# **Response to Requests for Additional Information for the Review of the ARCADIA<sup>®</sup> Reactor Analysis System for PWRs Methodology Description and Benchmarking Results Topical Report**

ANP-10297Q1NP  
Revision 0

AREVA NP Inc.

The ARCADIA® Topical Report [1-1] was submitted to the US Nuclear Regulatory Commission for review in March 2010. A draft set of Requests for Additional Information (RAI) was released by the NRC in December 2010. This document addresses the AREVA NP Inc. responses to a subset of these RAIs.

**Figure 31-A-1: Boron Differences**

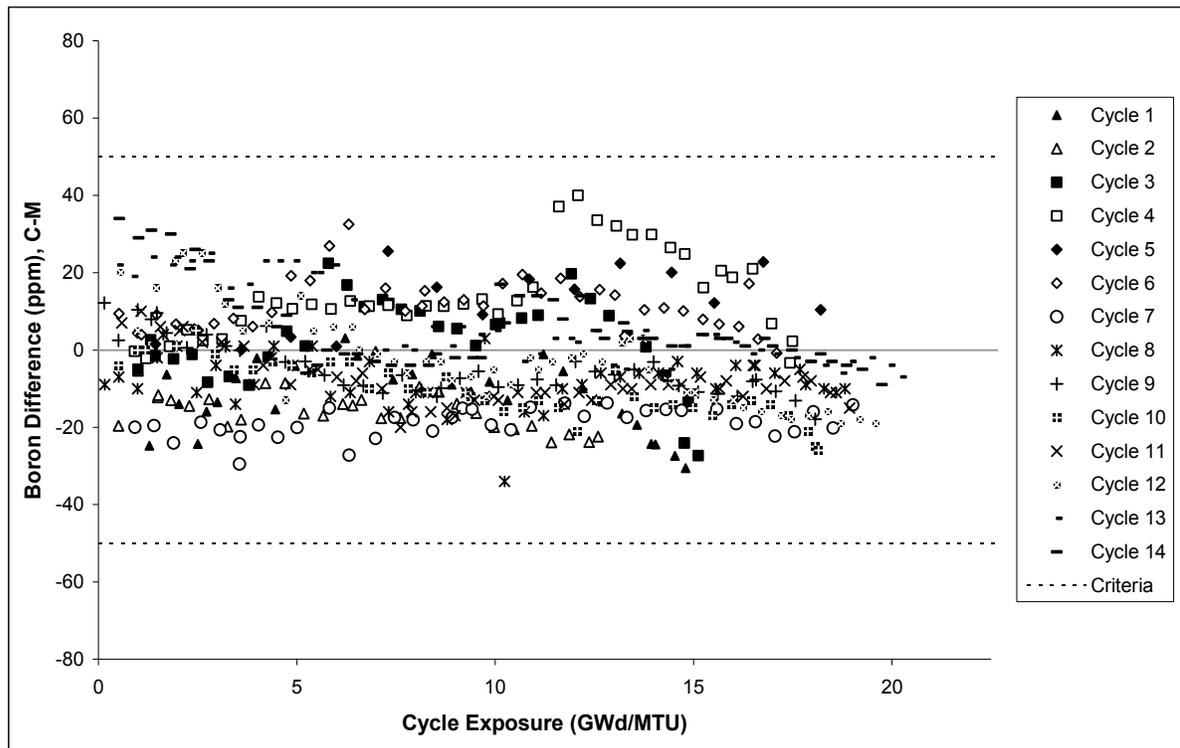
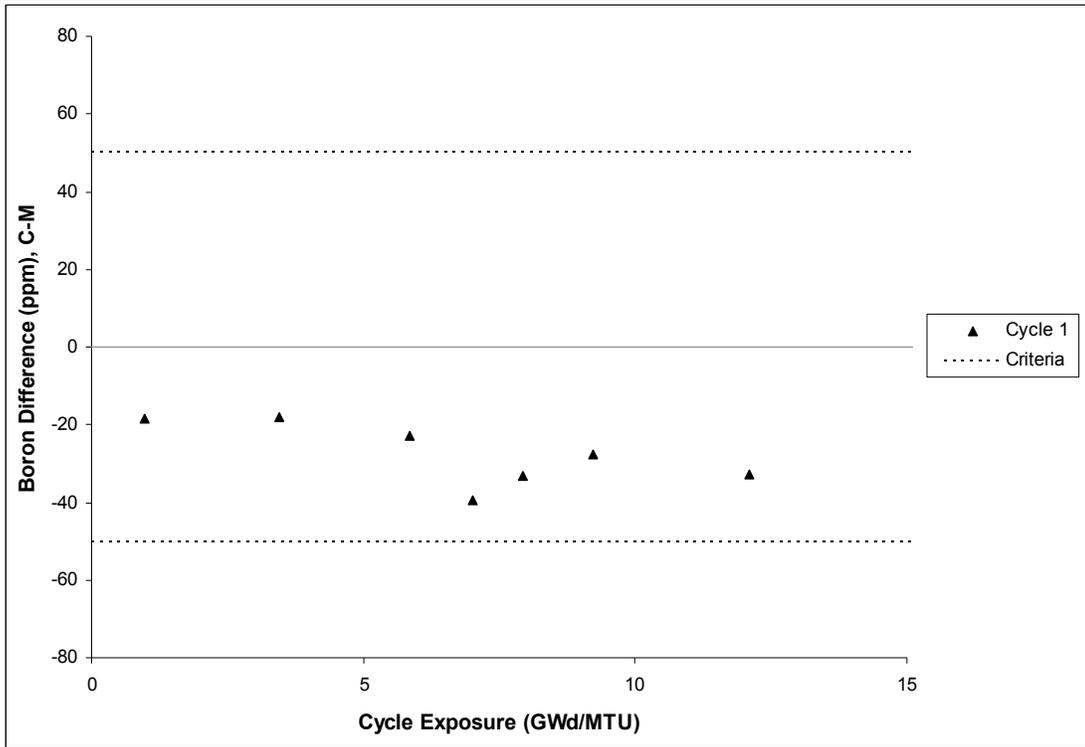
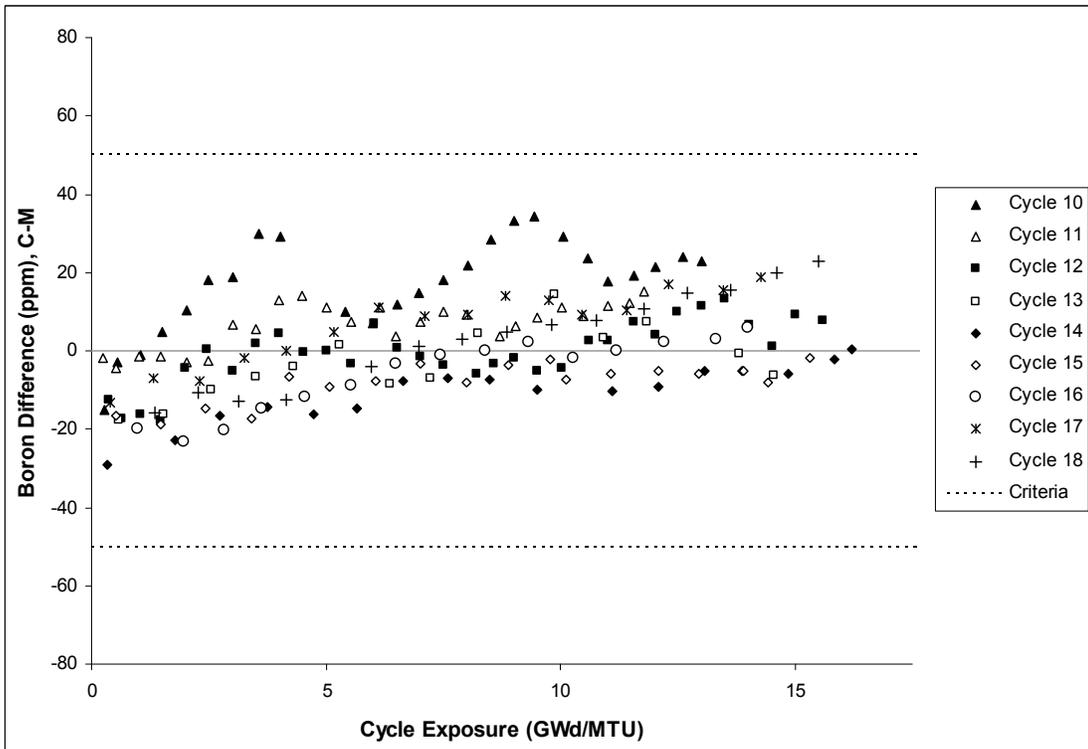
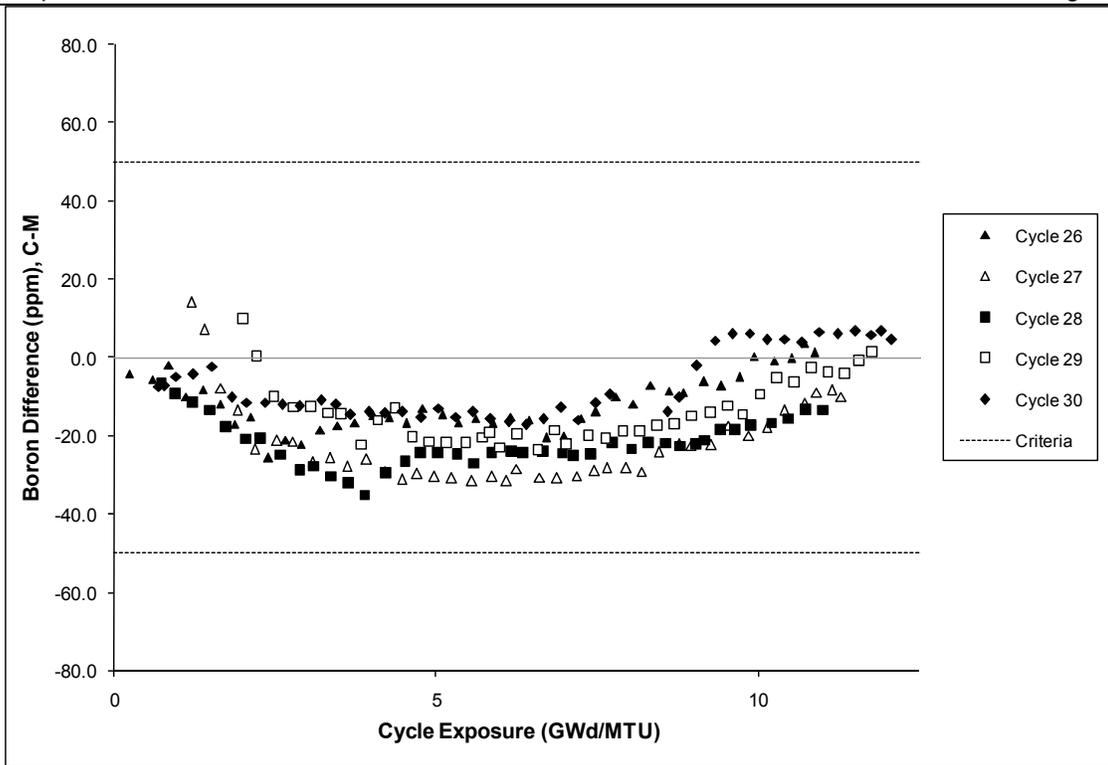
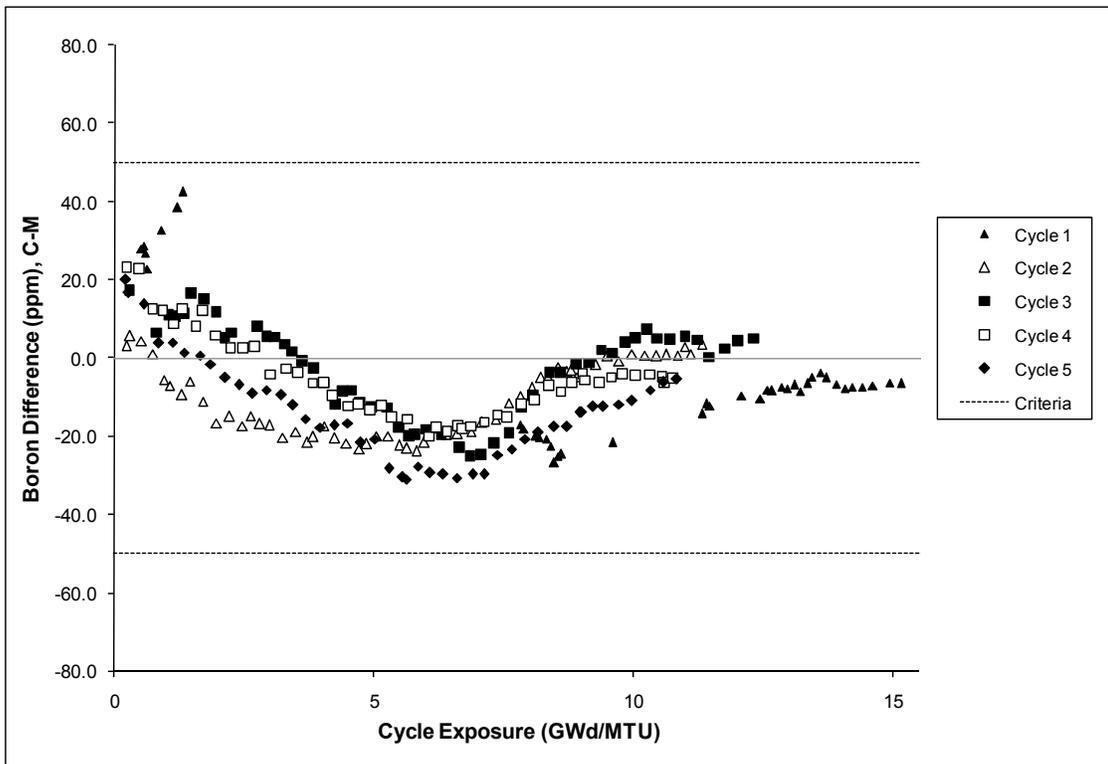
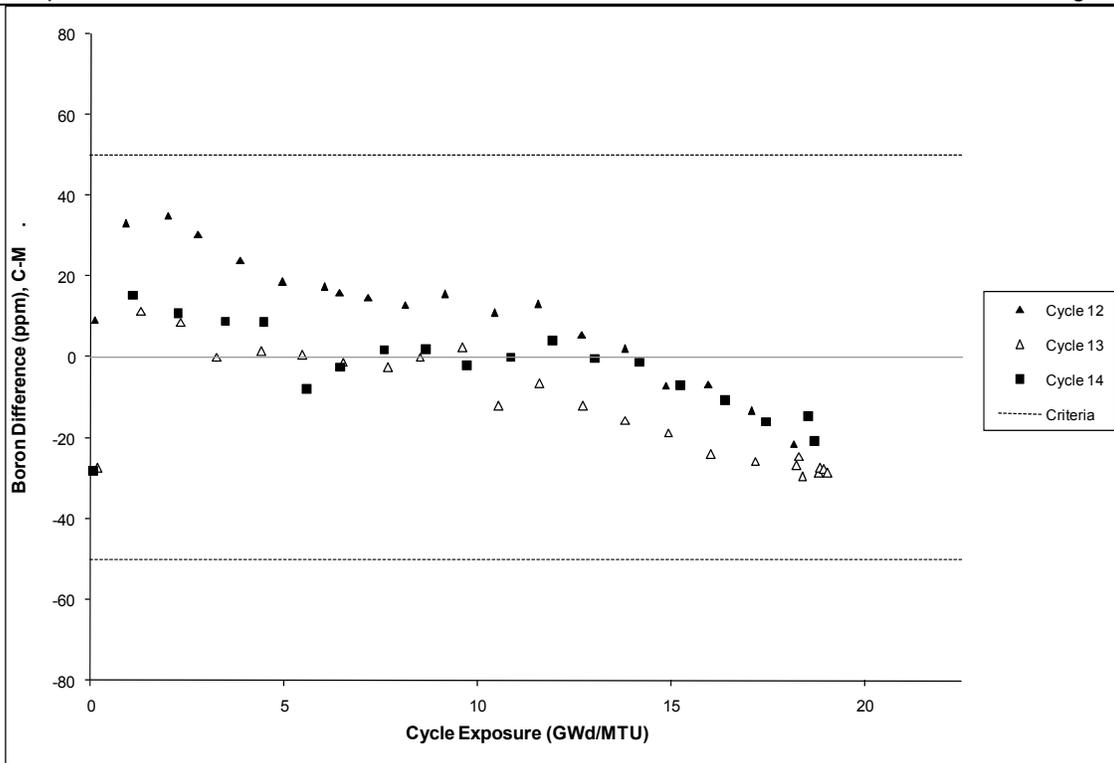
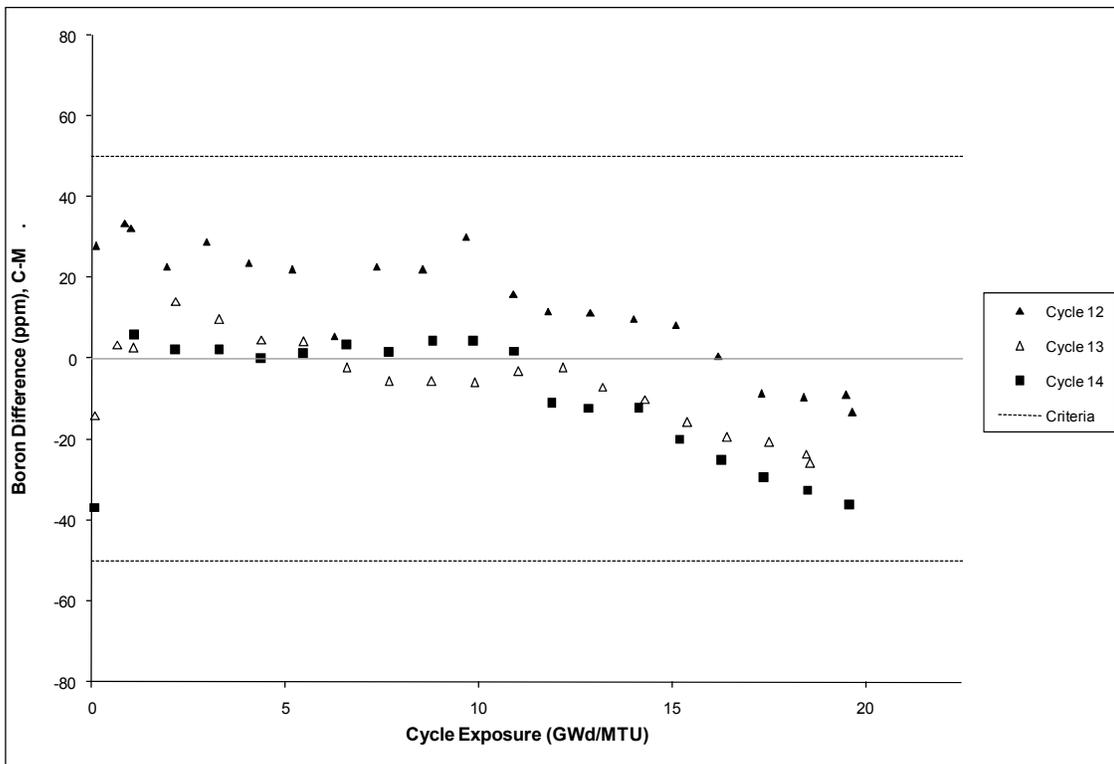
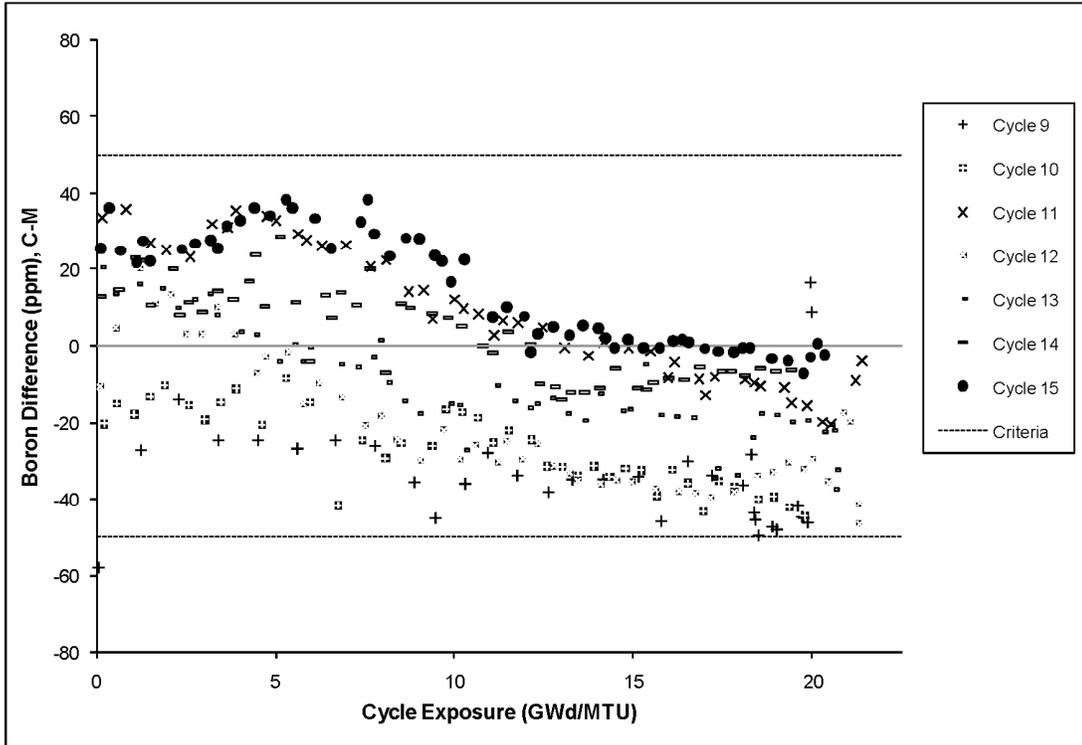
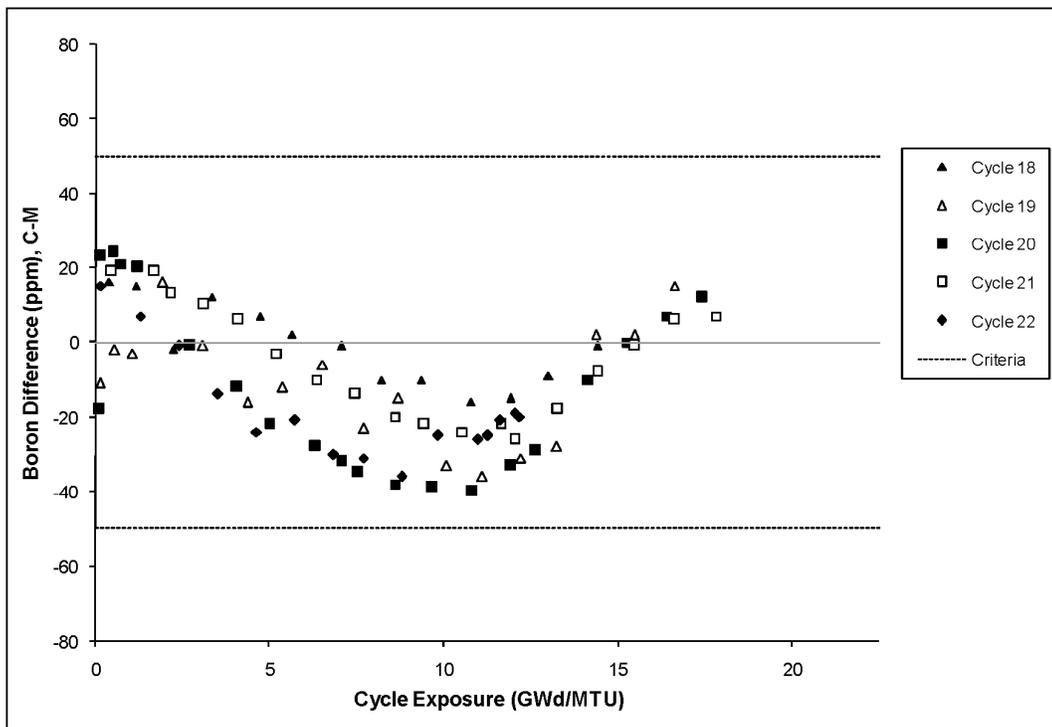
**RAI 31** The boron letdown curves are presented for each cycle individually as a function of fractional cycle length. This scale is confusing because it prevents some comparisons from cycle to cycle, and inhibits the ability to approximate cycle length-based effects, such as gadolinia depletion, B-10 depletion, and design implications for 24 vs 12 month cycles, etc. Furthermore, the letdown curves are presented on an absolute value scale, which makes individual deviations very hard to discern. A summary plot of boron difference for all cycles (to compare against each other, potential by plant), plotted versus a non-relative scale such as cycle exposure would be useful. [Page A-9+]

Summary plots of the boron deviations are provided. These plots use an absolute scale for burnup and present the boron deltas for all cycles by plant.
